MODIFICATION #1
WEST LILAC ROAD - BRIDGE TO HIGHWAY 395

**Request for a
Modification to a Road Standard
and/or to Project Conditions**

Project Number: TM 5571/5572 Date of Request: January 31, 2014

MODIFICATION TO ROAD STANDARDS

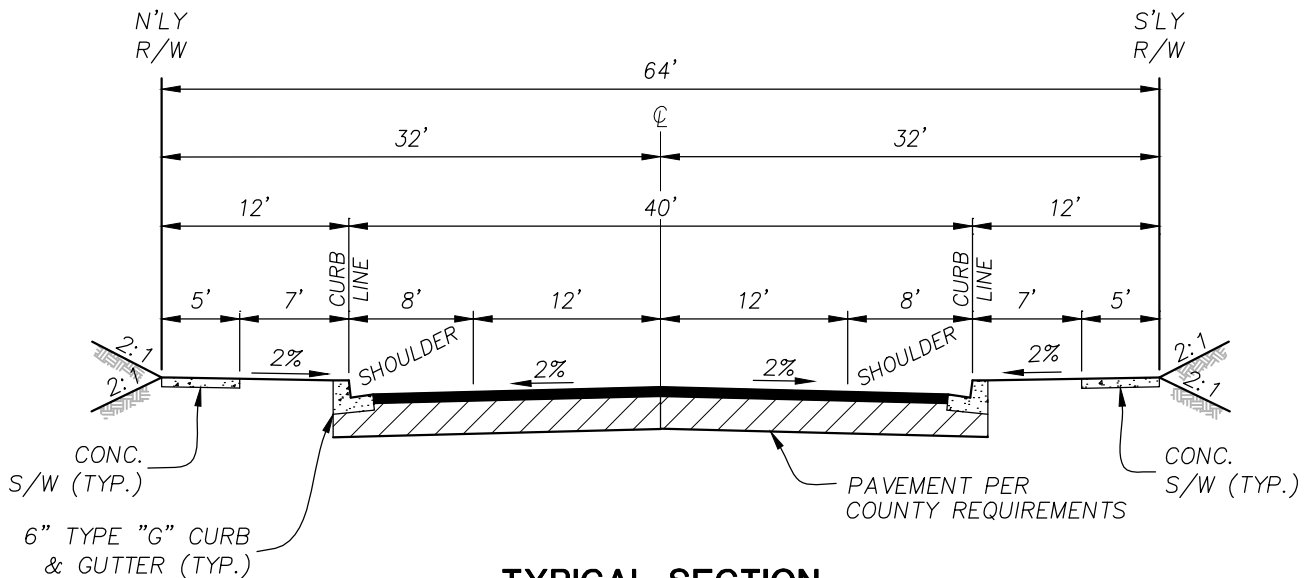
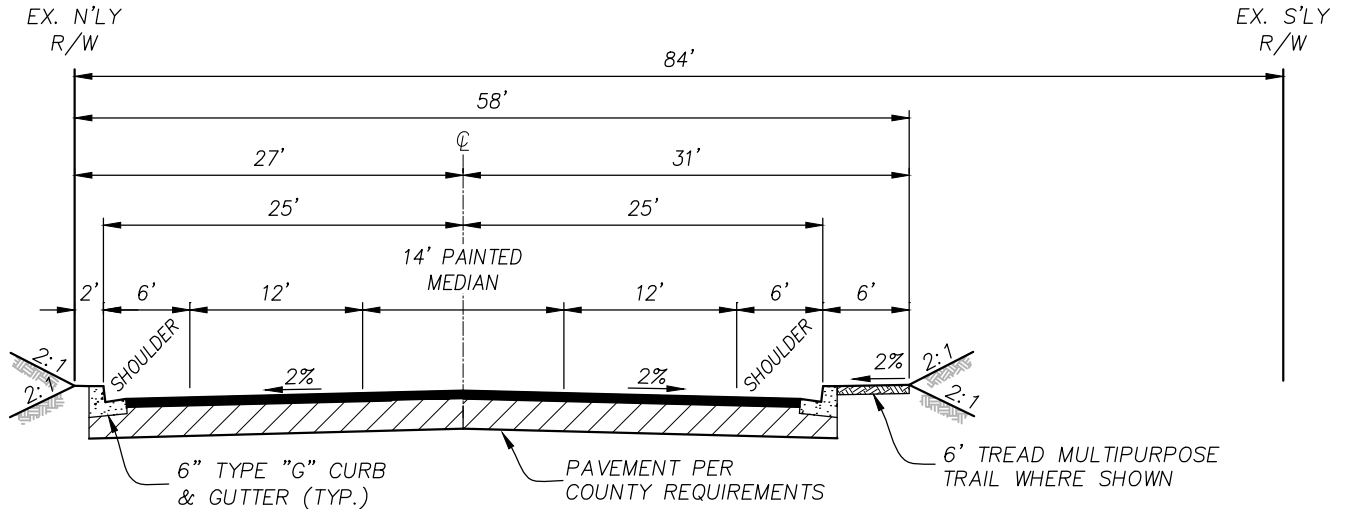
The standard road section for Light Collector Road 2.2C is 40'-54' wide curb to curb
width on 64'-78' ROW. 8' shoulders, and 12' parkways with a minimum design speed of 40 mph.
The requested modification to the road standard is to reduce the shoulder from to 6ft and
reduce the parkway to 2' (north) and 6' (south). Please see Attachment 1 for more information.

This portion of West Lilac Road offsite is a transition segment of the road from the
existing bridge over I-15 (with a travel way width of 24') to the intersection with Highway
395 where it will be difficult to construct the required full width (Light Collector 2.2c)
due to offsite grading and habitat disturbance as well as the need for offsite ROW condemnation.
Extensive grading and permission to grade from adjacent land owners on both sides would
be required to implement the standard roadway section (Light Collector 2.2c). West Lilac would
operate at LOS D or better with or without the requested modification.

*ATTACHMENT 2
WITH MODIFICATION #1
INTERSTATE 15 TO OLD HIGHWAY 395*

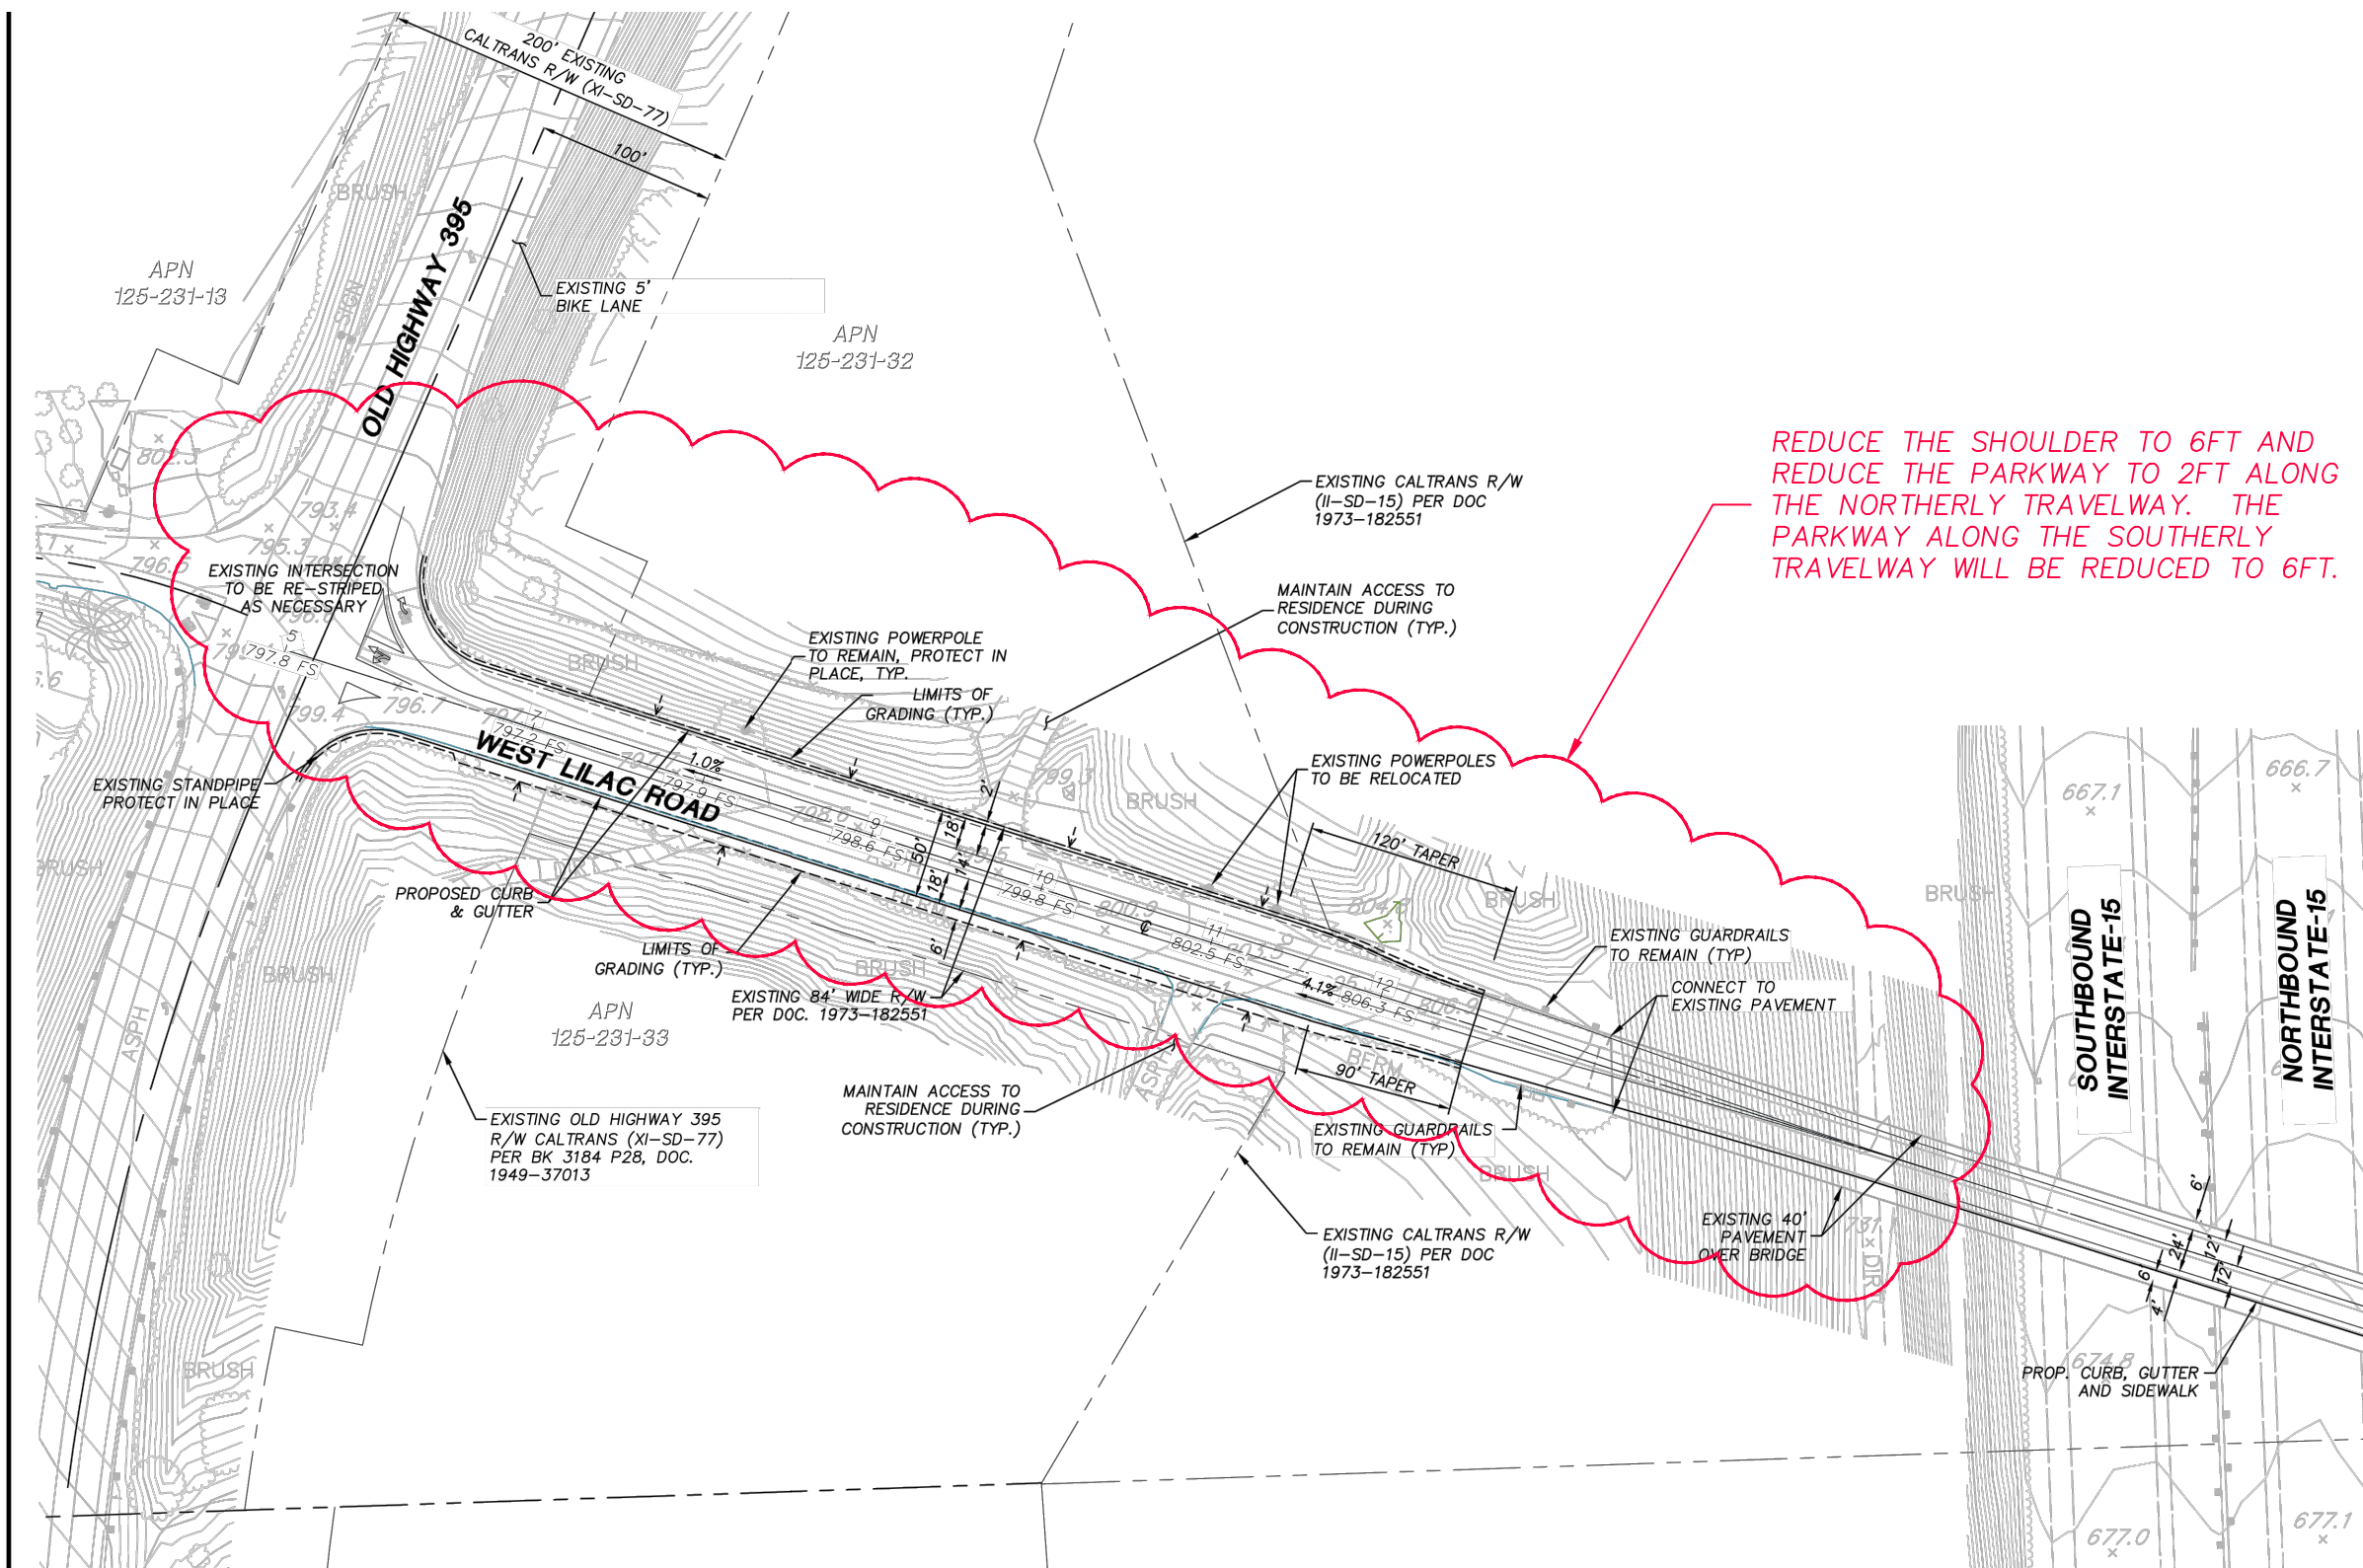
See Attachment 2 for road design with modification.
